## JOINT REGIONAL PLANNING PANEL (Sydney West)

JRPP No	2014SYW112
DA Number	DA0289/14
Local Government Area	Ku-ring-gai
Proposed Development	Demolish existing & construct new church hall & rectory
Street Address	3A Hill Street Roseville and 1 Bancroft Avenue, Roseville
Lot & DP	Lots 2, 3 and 4 in DP 1046733
Applicant	St Andrews Anglican Church Roseville
Owner	Anglican Church Property Trust Diocese of Sydney
Number of Submissions	Original proposal: 20 in support, 5 objections Amended proposal: 3 in support, 2 objections
Regional Development Criteria (Schedule 4A of the Act)	The proposed place of public worship has a CIV of over \$5 million and falls into the category of 'private infrastructure and community facility'
List of All Relevant s79C(1)(a) Matters	SEPP 55 – Remediation of Land SEPP (Sydney Harbour Catchment) 2005 SEPP (Infrastructure) 2007 Ku-ring-gai LEP (Local Centres) 2012 Local Centres DCP Development Contributions Plan 2010
List all documents submitted with this report for the panel's consideration	Attachment A – Pre DA Report Attachment B – Letter to applicant Attachment C – Heritage Consultant comments Attachment D – Clause 4.6 variation Attachment E – Plans and ele

**Figure 2 - Hill Street elevation showing height of proposed building and existing residential flat building. The 11.5m height limit is shown as a dashed line.**

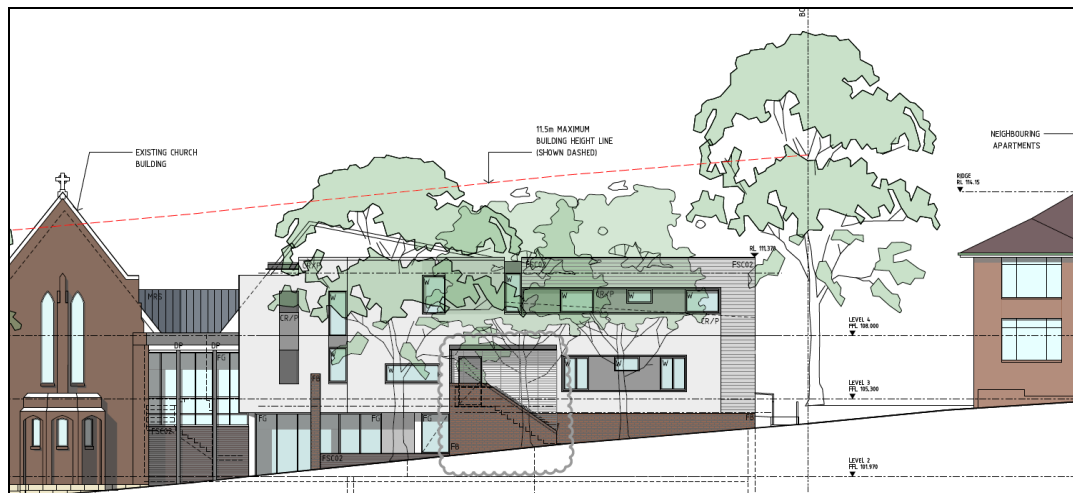
The applicant's argument that a development which retained the church and proposed a larger church hall would result in greater impacts on the apartment building at 3 Hill Street are overstated. The proposed building form envisaged by the applicant appears to be a 3 storey high structure built to the boundaries. The proposed floor space ratio is 0.76:1 and the maximum floor space ratio is 0.85:1. To achieve the maximum floor space ratio the gross floor area would only need to be increased by 188m<sup>2</sup>. In theory this increase could be achieved by filling in part of the void areas and making no changes to the building envelope. Alternatively, if changes to the building envelope were required it is unlikely that achieving an additional 188m<sup>2</sup> of floor area (an 11.8% increase in a 1580m<sup>2</sup> building) would require an additional storey with the same footprint as the storey below. If the height of the building at 3A Hill Street was increased the additional shadowing impact on the apartments at the north-western corner of the building would be offset by providing an open outlook to the apartments located in north-eastern corner of the building and the common area located at the rear of the residential flat building. If adequate setbacks from the southern boundary were provided it is likely that an additional storey on the Hill Street elevation would have minimal impact on solar access to the apartments at 3 Hill Street.

**Figure 4 - The existing landscape corridor at the rear of 1-17 Bancroft Avenue contains trees and ancillary structures**

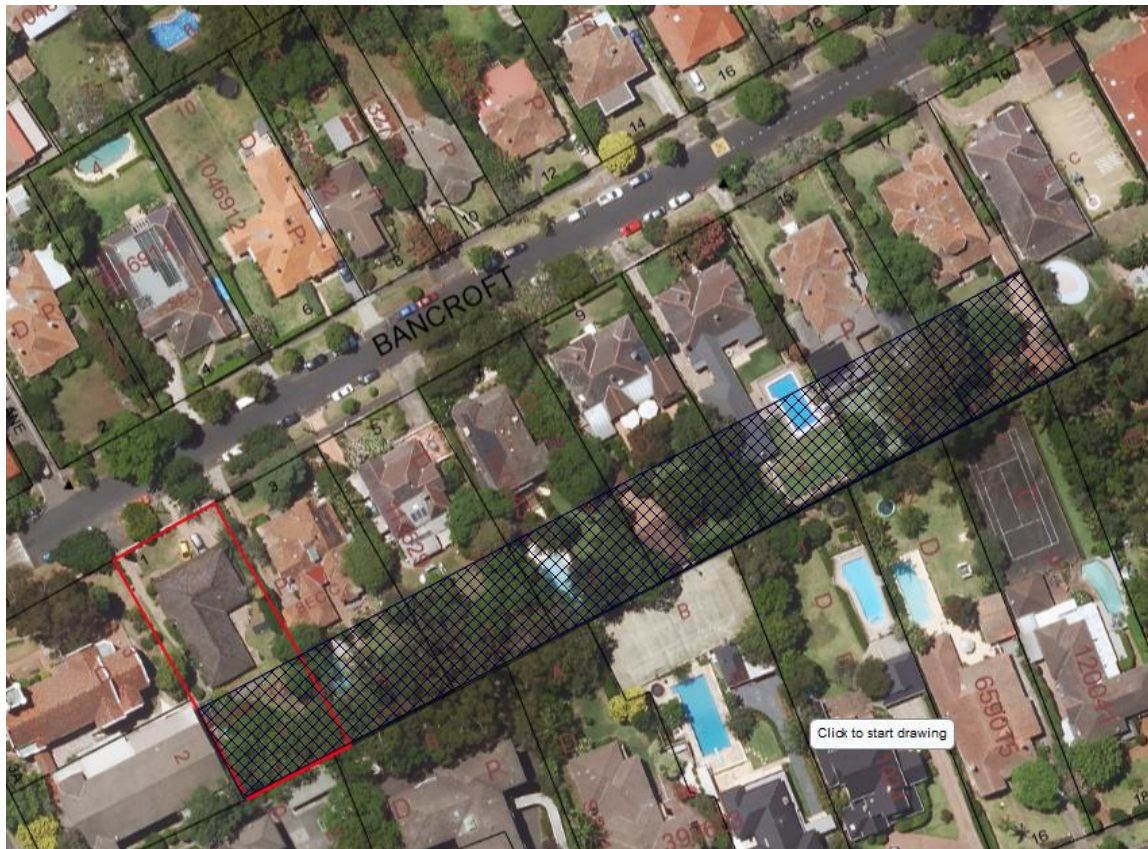
The photomontage is not an accurate representation of the development as it shows tree canopies to the southern and eastern sides of proposed building. The development seeks to remove 7 of the 8 trees located in the backyard of 1 Bancroft

Avenue. The retention of a single Brushbox tree in the south-western corner of the site will not achieve the landscape setting described in the photomontage. Figure 4 shows the existing landscaped corridor at the rear of Nos. 1-17 Bancroft Avenue.
